**BOARD ACTION REPORT – APPEALABLE ITEM**

**Project Name:** 701 SE 1<sup>st</sup> Street  
**Project Location:** 701 SE 1<sup>st</sup> Street  
**Request:** Certificate of Appropriateness  
**Board:** Historic Preservation Board  
**Meeting Date:** March 7, 2017

### ---STAFF REPORT---

**ITEM:** 701 SE 1<sup>st</sup> Street, Marina Historic District (2017-102) – Certificate of Appropriateness for replacement of the roof for a contributing structure.

A7.0

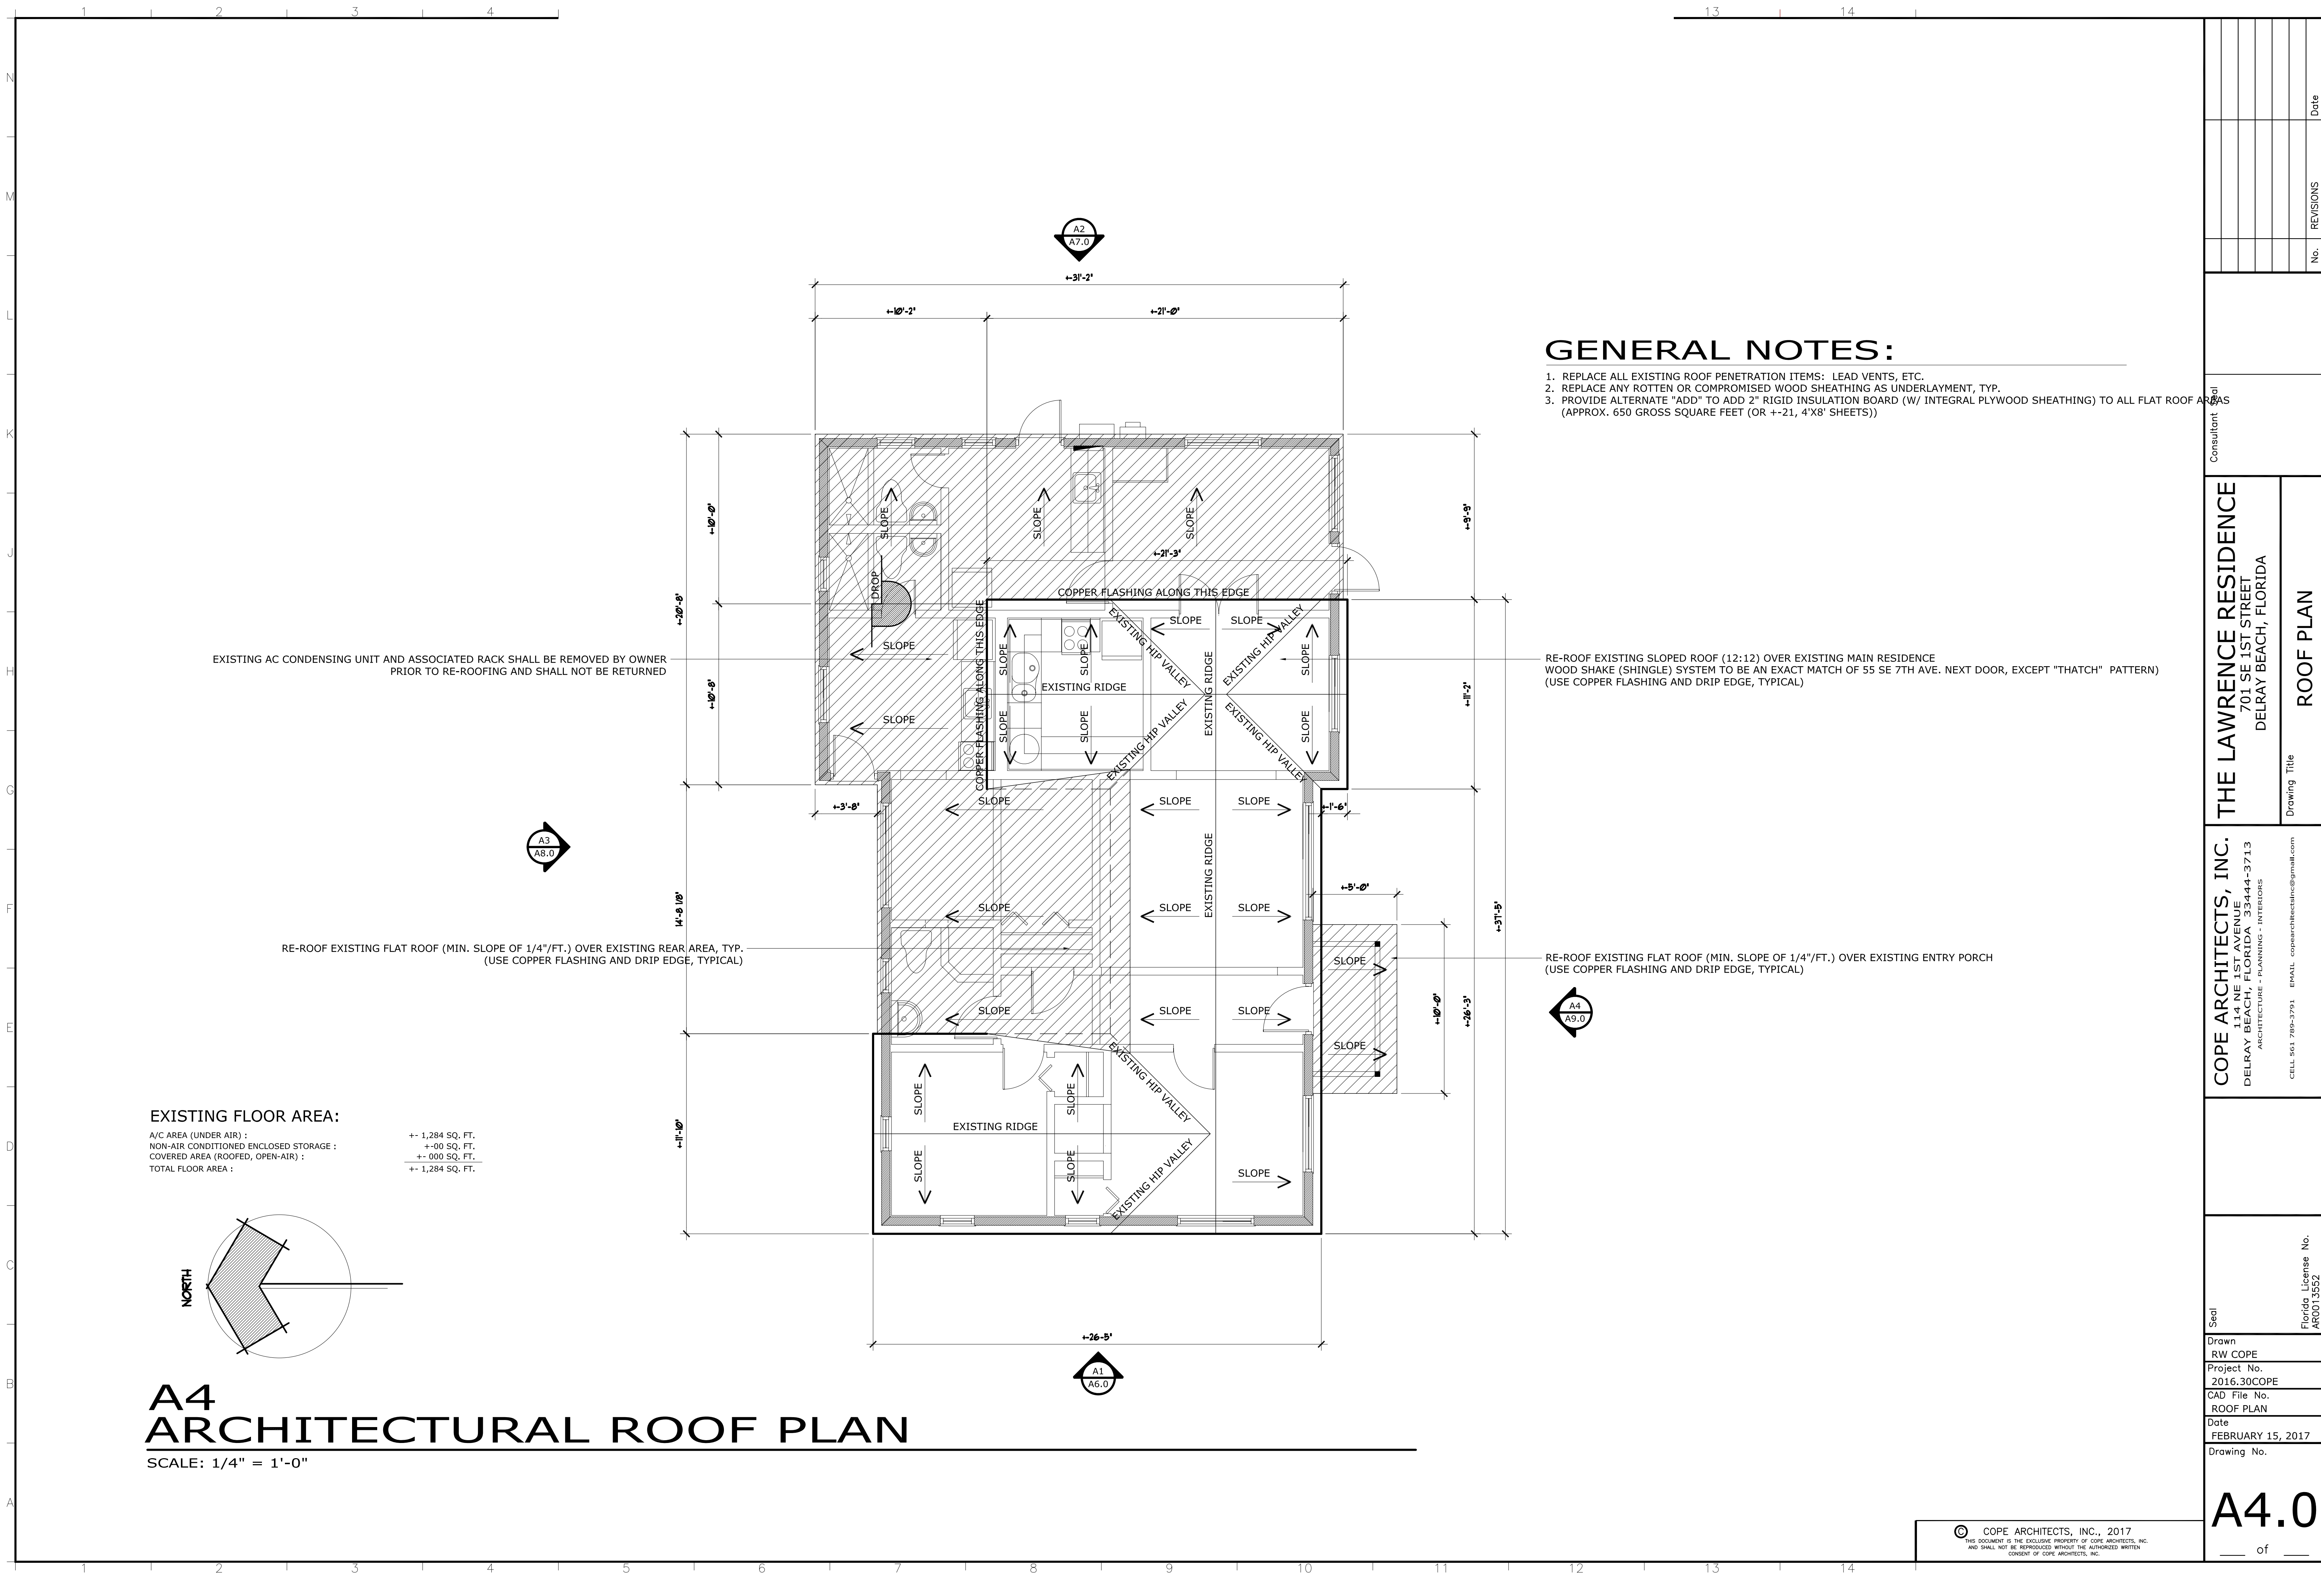
The proposal to install a thatch patterned cedar wood shake roof on the contributing structure can be considered appropriate with the subject structure, as the texture is similar to the structures original composition shingle roof. The proposed roof would be visually compatible with surrounding structures, specifically the structure to the north which has a new cedar wood shake roof in a traditional pattern. It is the "thatch" pattern that provides for variety in appearance.

The installation of this roof type, will not alter the historic character as this was a roofing material and pattern that was utilized in the time period for which the structure was built.
